**PITTSBURG UNIFIED SCHOOL DISTRICT
HIGHLANDS ELEMENTARY SCHOOL
PORTABLES REPLACEMENT PROJECT**

**BID ADDENDUM NO. 3
May 5, 2026**

PROJECT: Highlands Elementary School – Portables Replacement
4141 Harbor St, Pittsburg, CA 94565

CSK-01

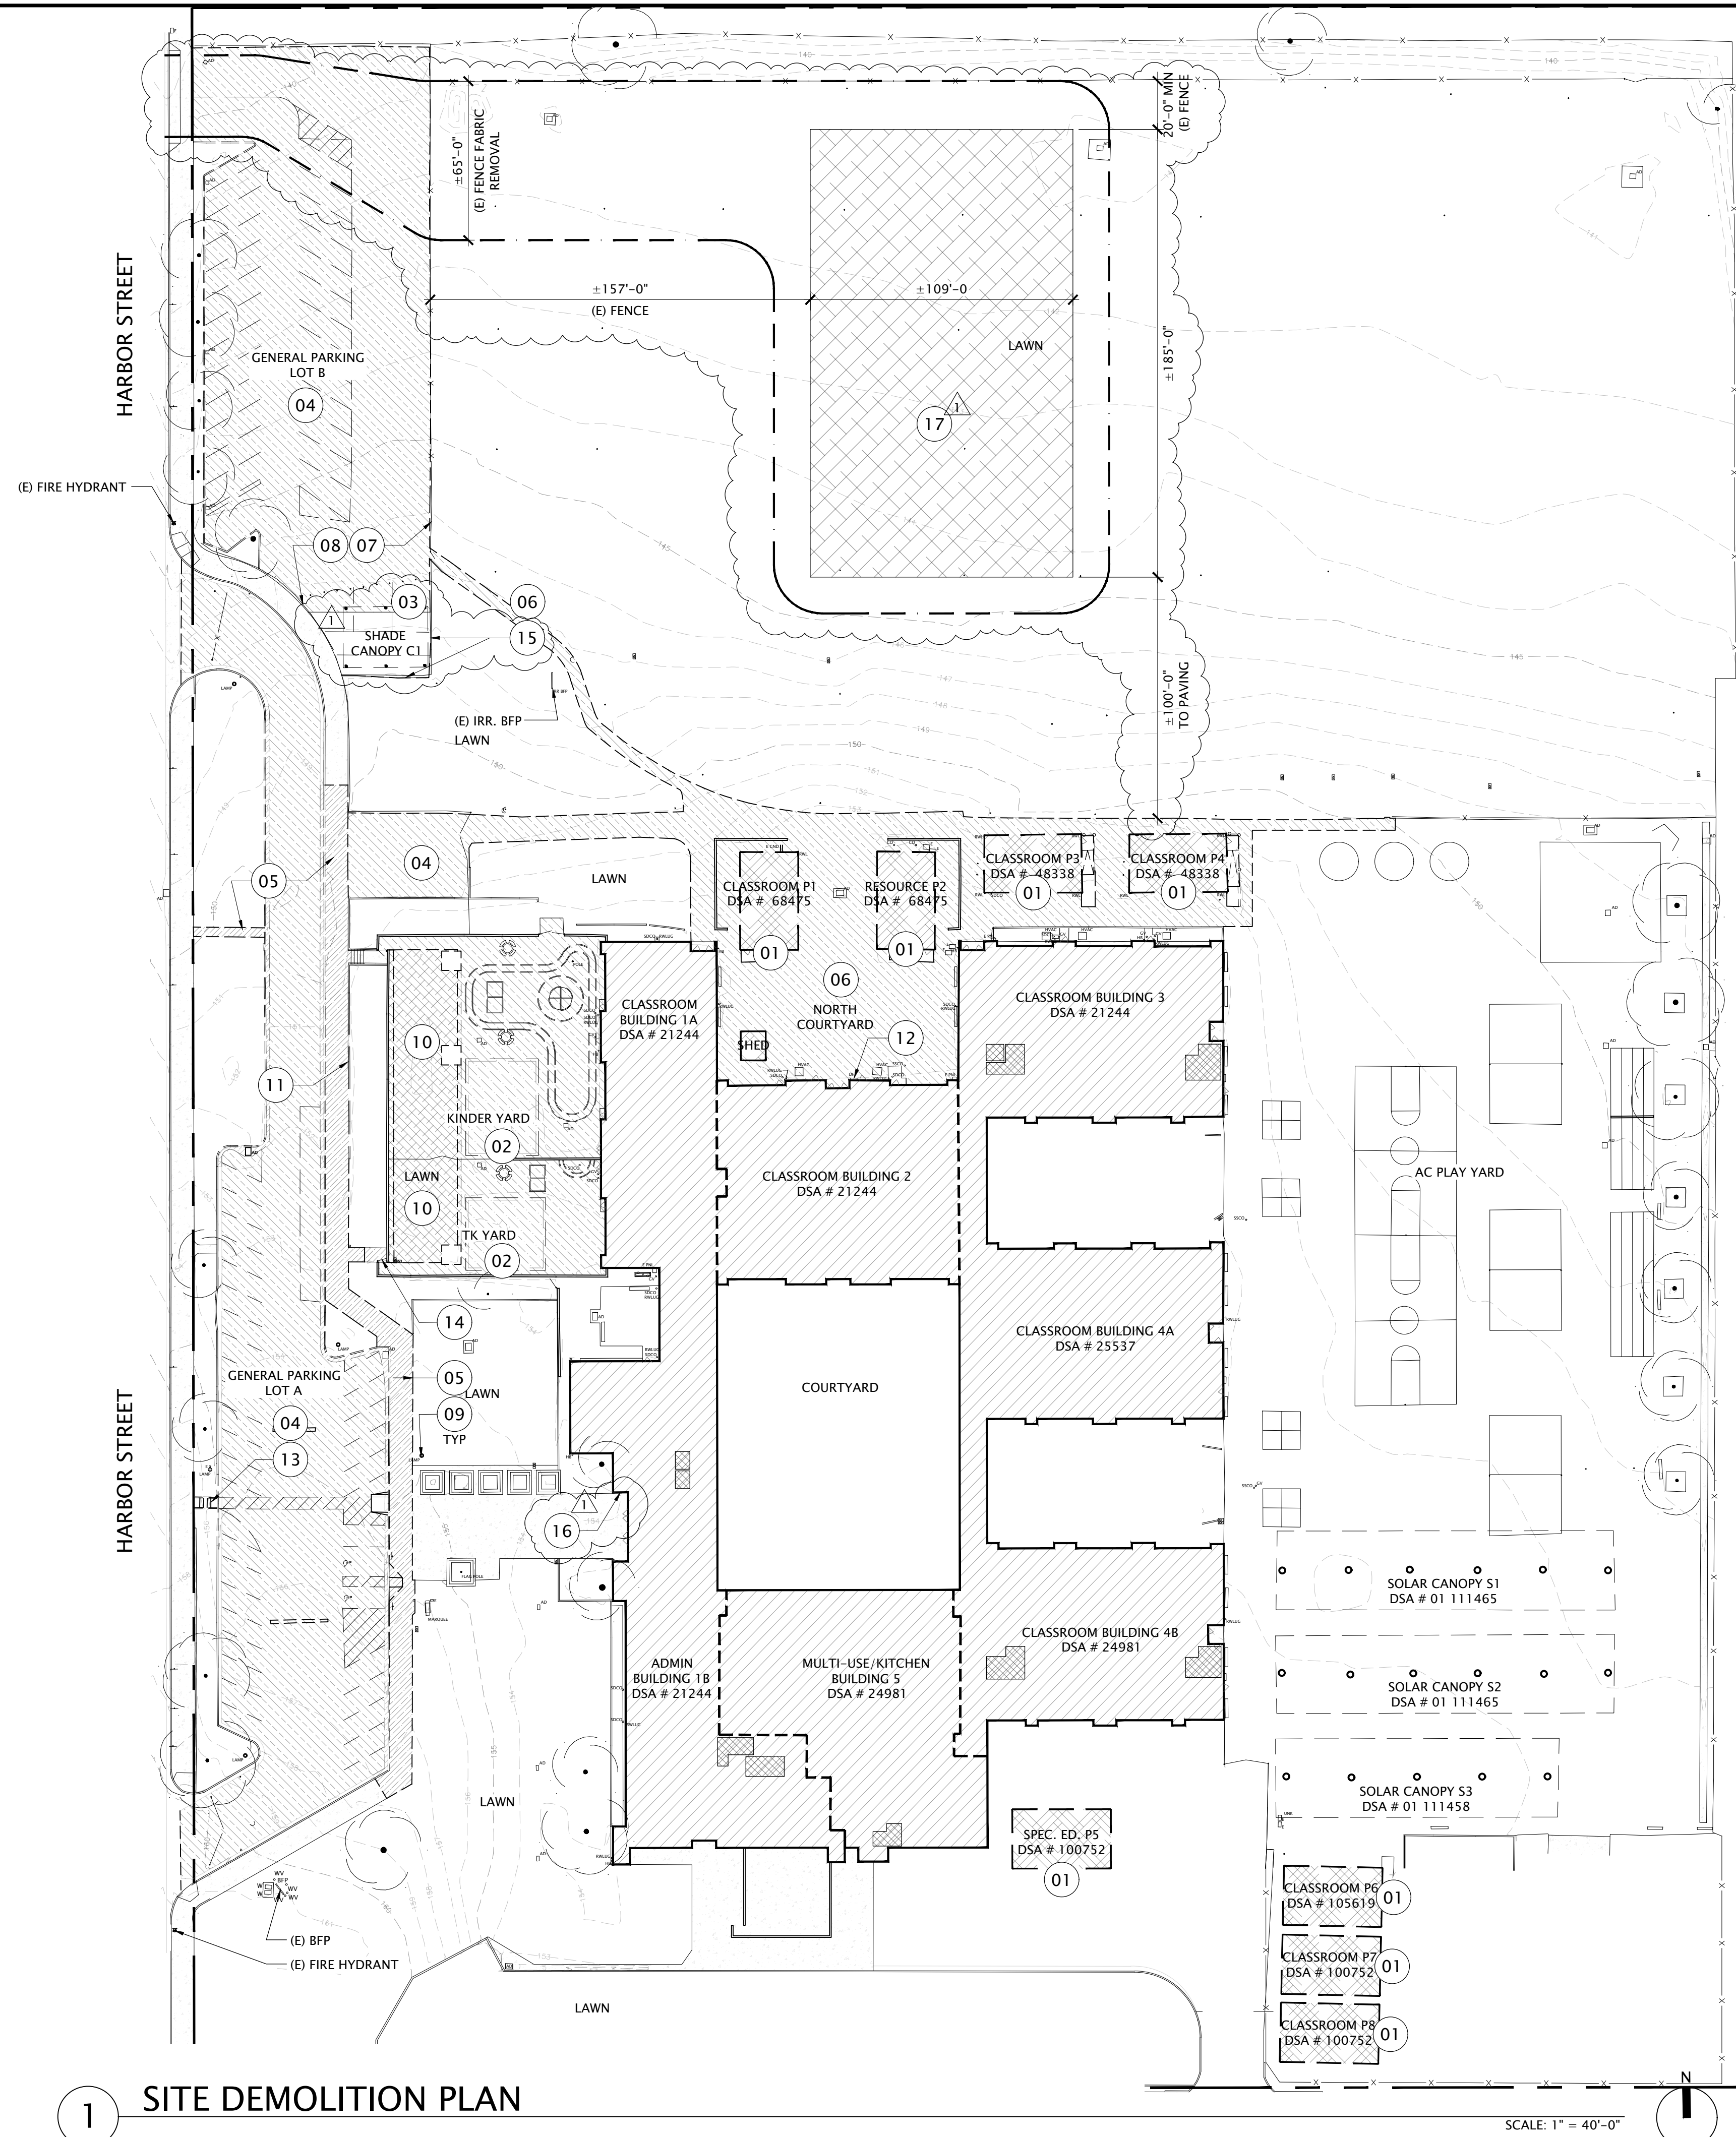
Reference: C2.05 & C2.06 – Grading & Drainage Plans
Attachment: CSK-01 - EARTHWORK NOTES
Description: Add Note 5 to Earthwork and Soils Notes per the attached CSK-01.

5. THERE WILL BE APPROXIMATELY 3000 CY YARD OF SOIL STOCK PILED TO BE USED FOR PROJECT FILL ON THIS PROJECT. CONTRACTOR SHALL UTILIZE THE STOCKPILED SPOILS DEPOSITED AT THE SITE TO THE EAST OF GENERAL PARKING LOT B, AS A PORTION OF THE BUILDING PAD. INSTALL IN LIFTS OF 8" AND COMPACT TO 90% PER GEOTECHNICAL RECOMENDATIONS. CONTRACTOR SHALL REGRADE THE STOCKPILE SPOILS AREA LEVEL, REPLACE THE IRRIGATION, 6" TOPSOIL AMENDMENT AND HYDROSEED TURF.

A1.01

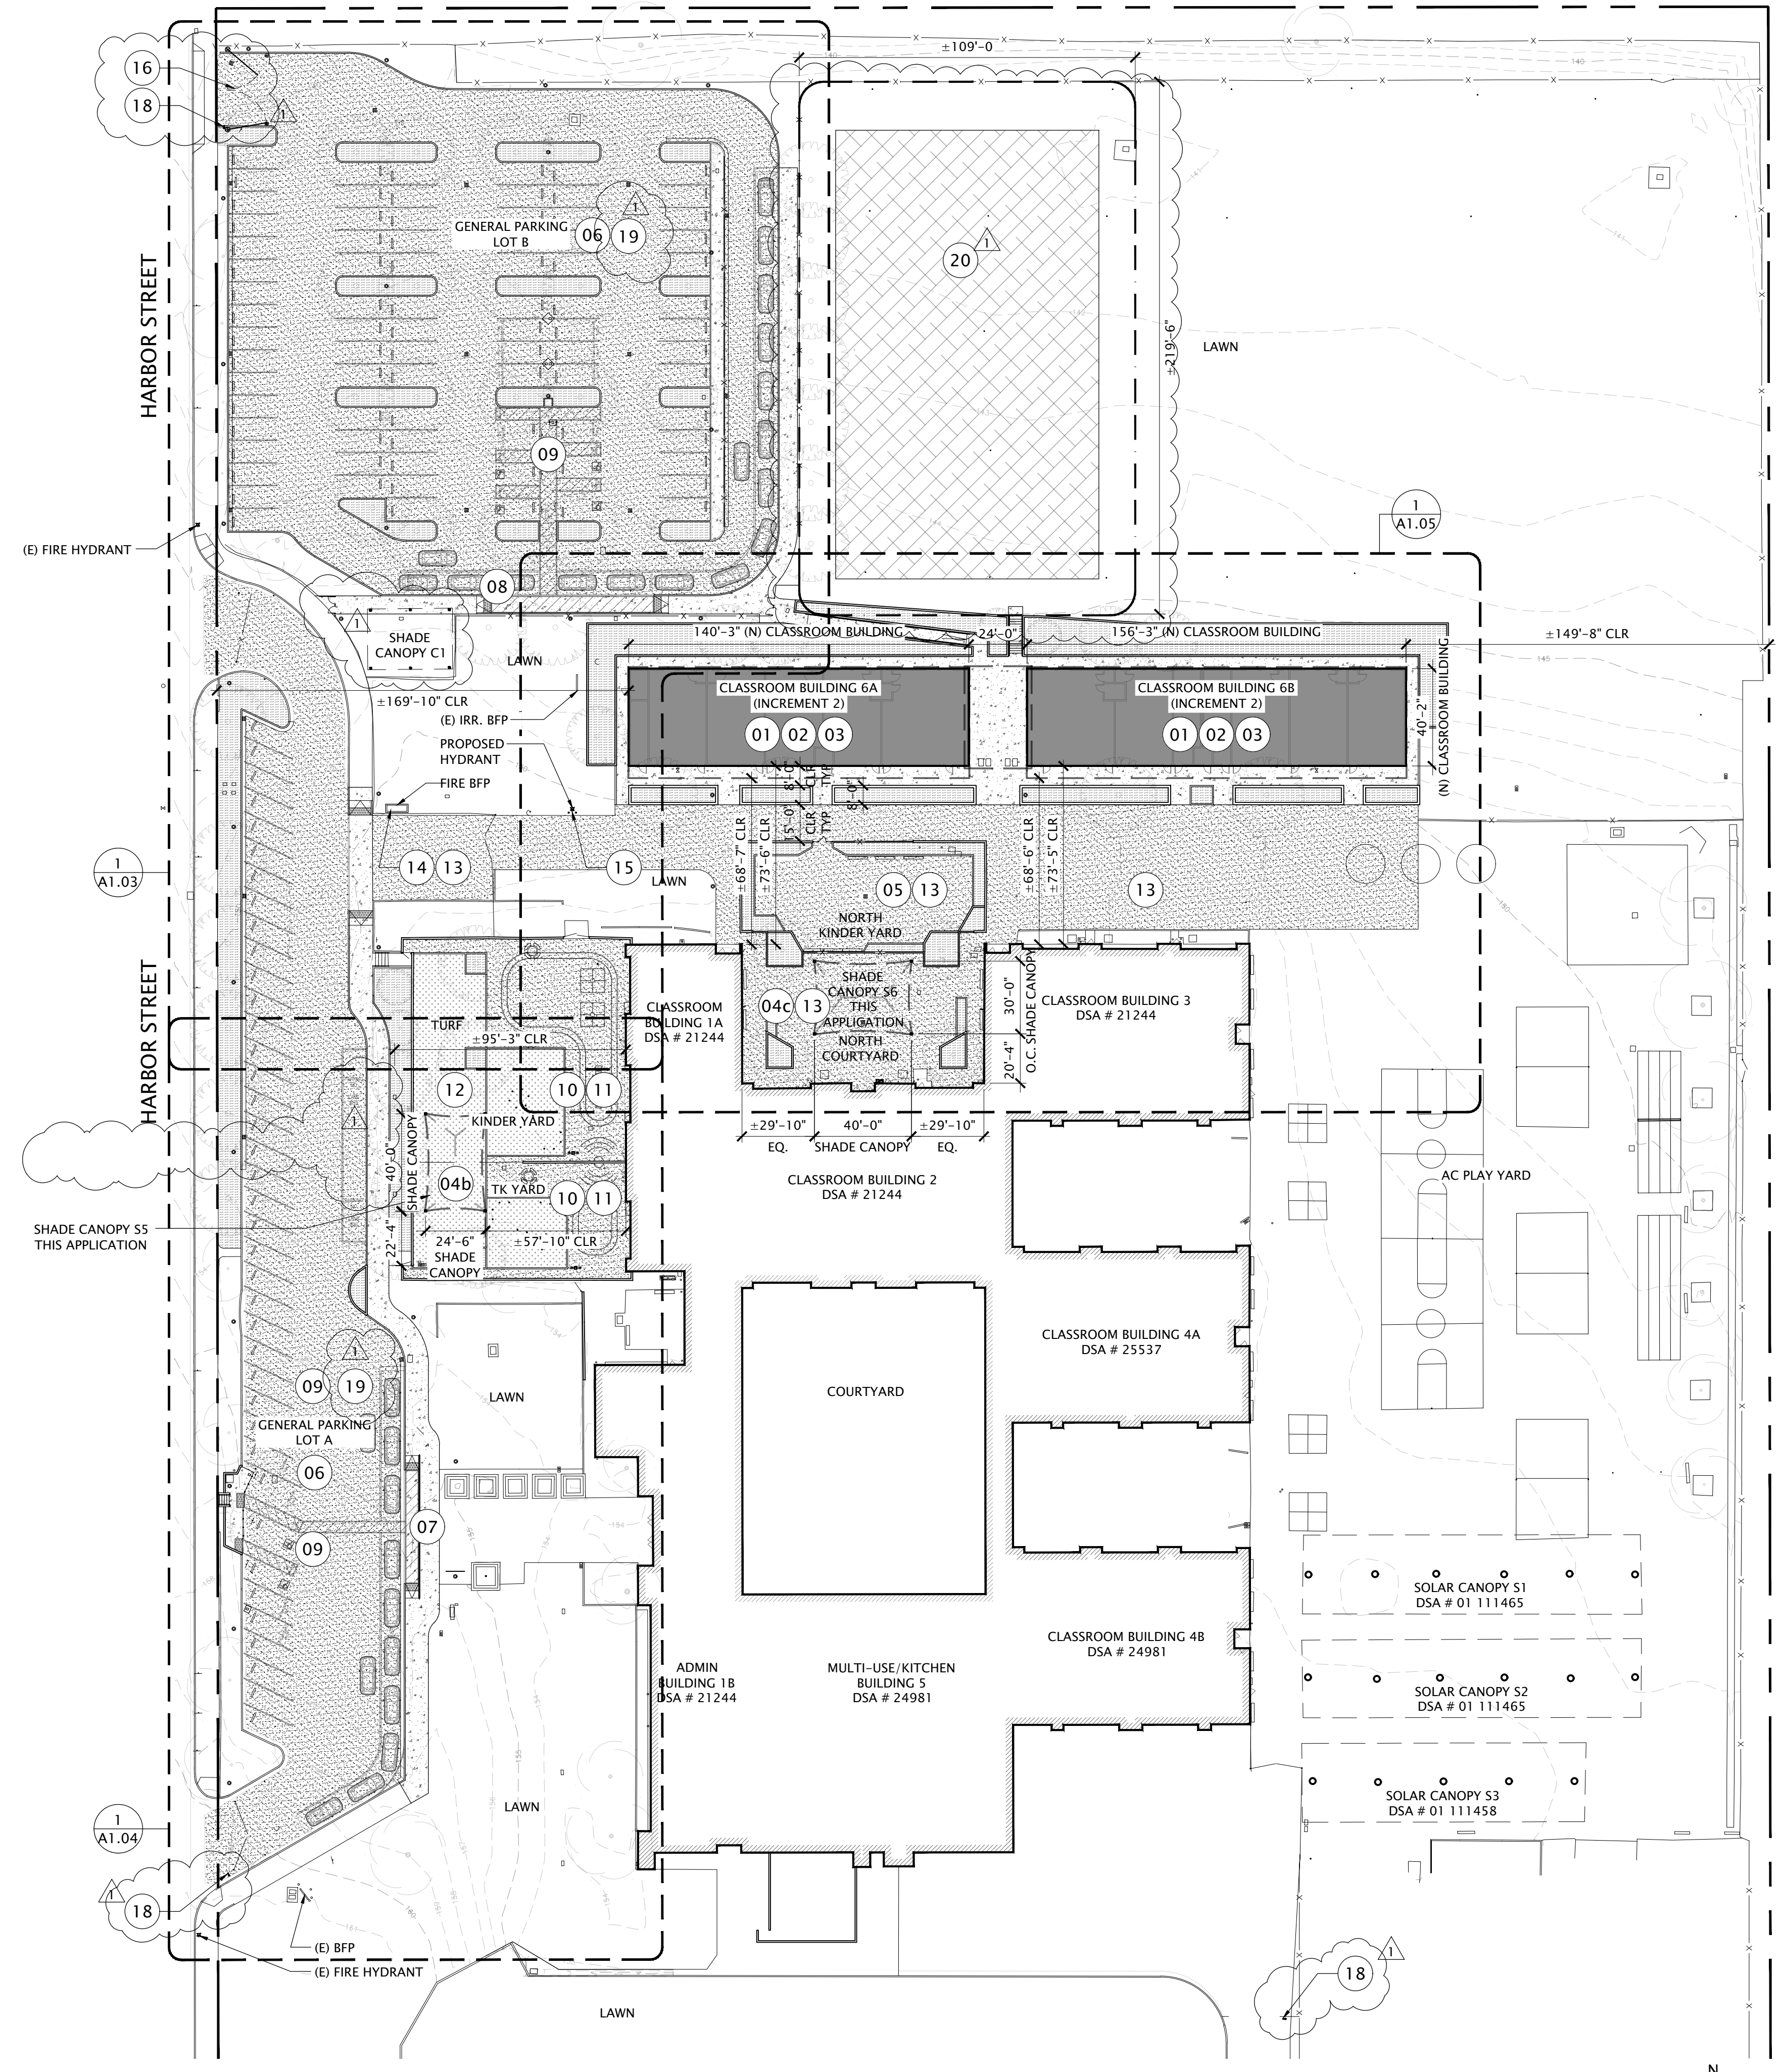
Reference: A1.01 - SITE DEMOLITION PLAN
Attachment: A1.01 - SITE DEMOLITION PLAN
Description: 1) Replace Keynote 3 to read; "Existing shade structure to remain, protect."
2) Add Keynote 17 to read as follows: 'Contractor shall utilize the stockpiled spoils deposited at the site to the east of General Parking Lot B, as a portion of the building pad fill. Contractor shall scrub and grub existing field in this area (31,000sf) removing the existing irrigation and top 6" of turf.'

- 16 REMOVE & REPLACE (E) WALL-MOUNTED KNOX BOX IN LOCATION.
- 17 CONTRACTOR SHALL UTILIZE THE STOCKPILED SPOILS DEPOSITED AT THE SITE TO THE EAST OF GENERAL PARKING LOT B, AS A PORTION OF THE BUILDING PAD FILL. CONTRACTOR SHALL SCRUB AND GRUB EXISTING FIELD IN THIS AREA REMOVING THE EXISTING IRRIGATION AND TOP 6" OF TURF.
